## **FINAL DRAFT REPORT**

### **WHITBY TS #1 – CAPACITOR BANK INSTALLATION IESO EXPEDITED ASSESSMENT – 2007-EX333 ASSESSMENT SUMMARY**

Whitby TS – Exist DESN # 1  
Proposed One New Capacitor Bank

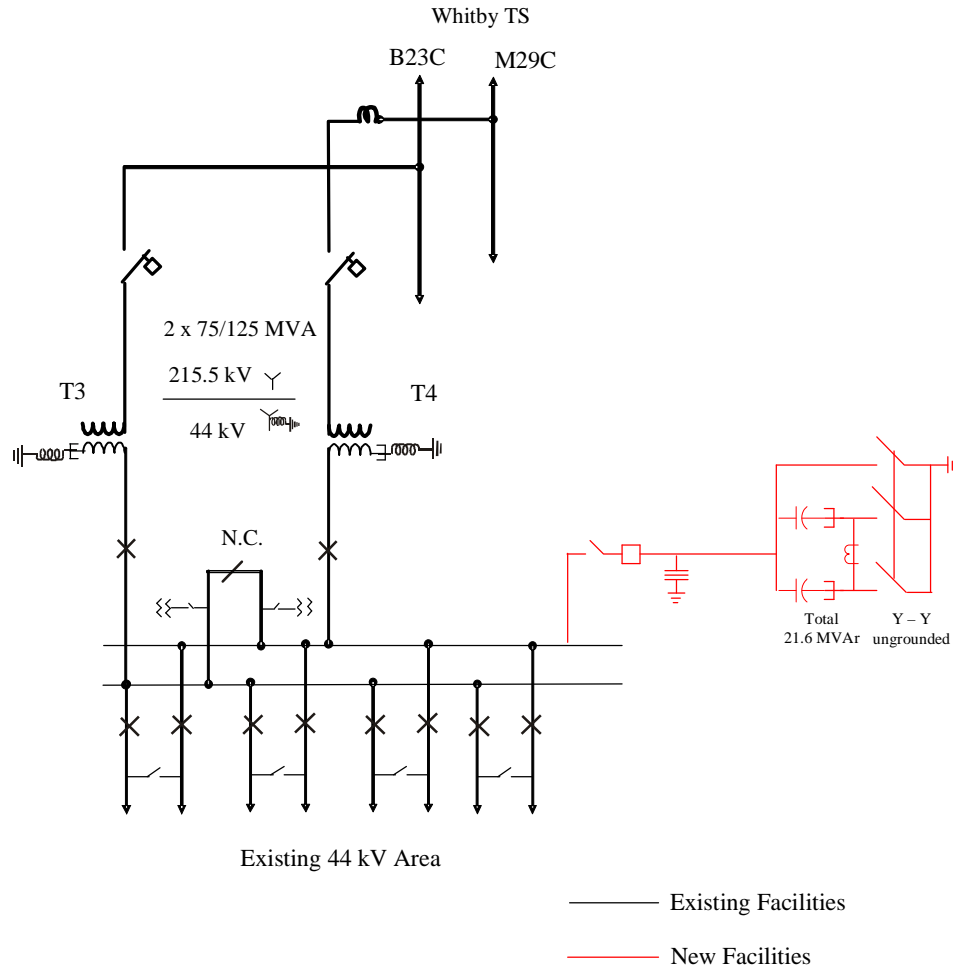
The proposed project involves the installation of one 21.6 Mvar LV shunt capacitor bank and some related equipment as shown in the following figure.

The study shows that the maximum steady state voltage change resulting from the capacitor switching is 1.81% which would be within the Market Rules requirement of 4%.

The IESO has concluded that the proposed installation of LV shunt capacitor banks will improve power factor at Whitby TS #1 and not have a negative effect on the reliability of the IESO-controlled grid.

It is therefore recommended that a Notification of Approval of the Connection Proposal be issued.
